COMDTNOTE 16500
JUNE 25, 2001

Subj: CH-1 TO ALTERNATING CURRENT AIDS TO NAVIGATION SERVICING
GUIDE, COMDTINST M16500.17

CH-1 TO ALTERNATING CURRENT AIDS TO NAVIGATION SERVICING GUIDE,
COMDTINST M16500.17

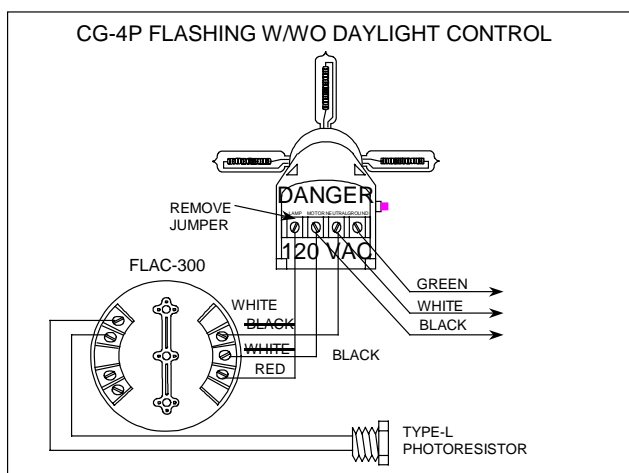
1. Add to the inside of the front cover “Change 1 entered (current date)”.
2. Page 2-10, paragraph e, change “above” to “below”.
3. Page 2-14 and page 2-28, paragraph m, add to the first sentence “Press the TEST button to”.
4. Page 2-20, paragraph I, delete the word “offset”.
5. Page 2-20, figure 2-14, add “(old style bracket)”.
6. Figures 2-6, 2-17, 2-22 and 4-4, change the notations between the flasher and lampchanger to read “White, Black and Red”, as shown below:

Figure 3-3 (without heat switch)

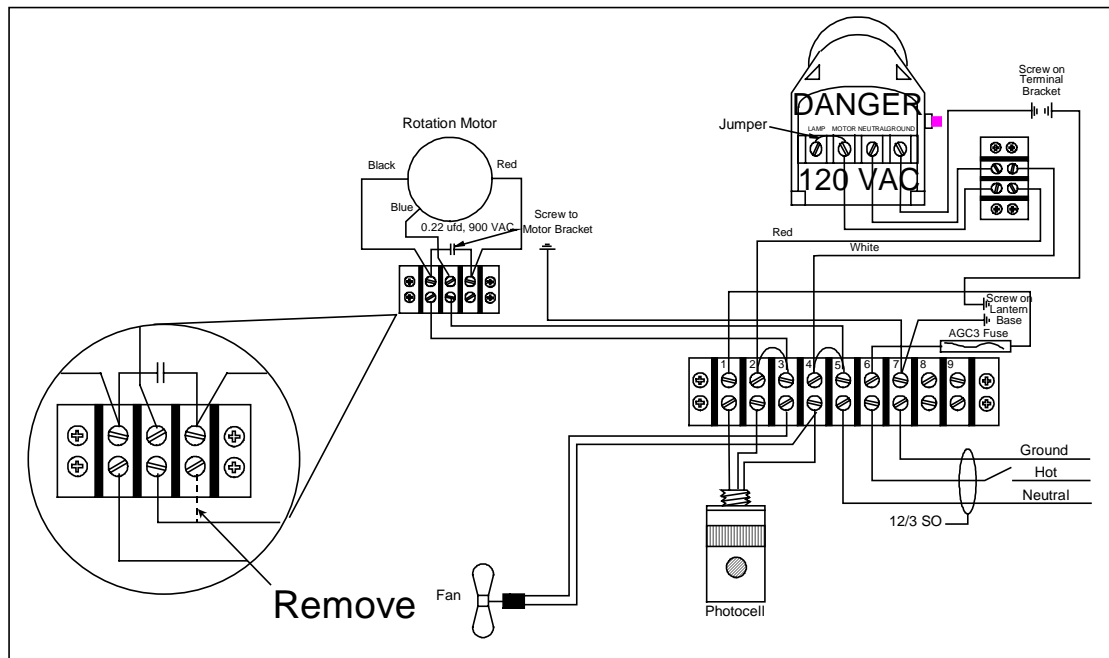
7. Figure 3-3, cross out the jumper on the small terminal strip connected to the rotation motor, and add the notation “(without heat switch)”, as shown below:

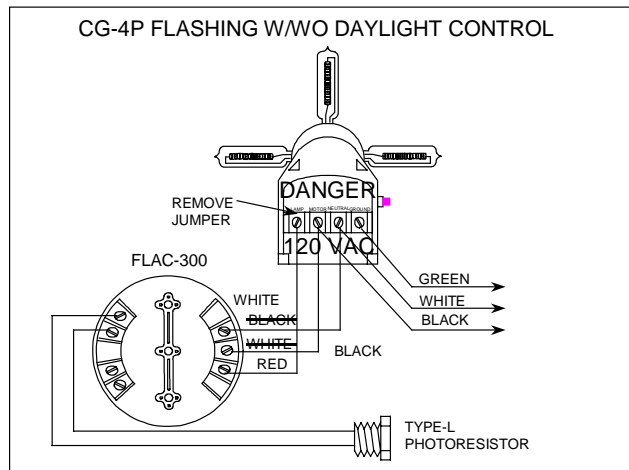
1. Add to the inside of the front cover “Change 1 entered (current date)”.
2. Page 2-10, paragraph e, change “above” to “below”.
3. Page 2-14 and page 2-28, paragraph m, add to the first sentence “Press the TEST button to”.
4. Page 2-20, paragraph I, delete the word “offset”.
5. Page 2-20, figure 2-14, add “(old style bracket)”
6. Figures 2-6, 2-17, 2-22 and 4-4, change the notations between the flasher and lampchanger to read “White, Black and Red”, as shown below:

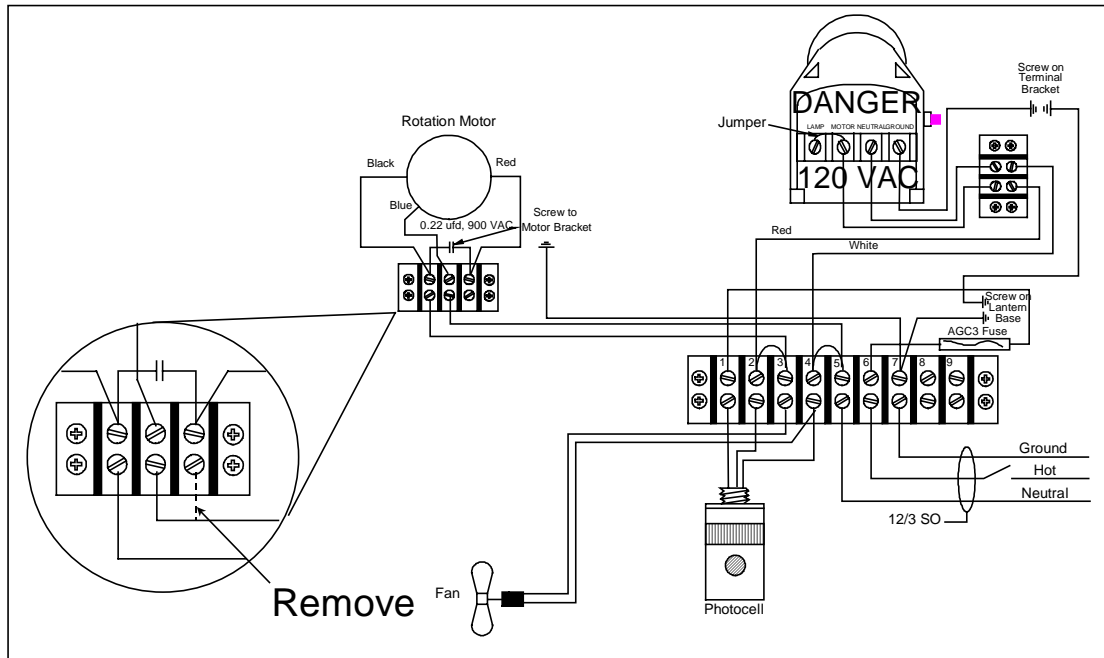
7. Figure 3-3, cross out the jumper on the small terminal strip connected to the rotation motor, as shown below:
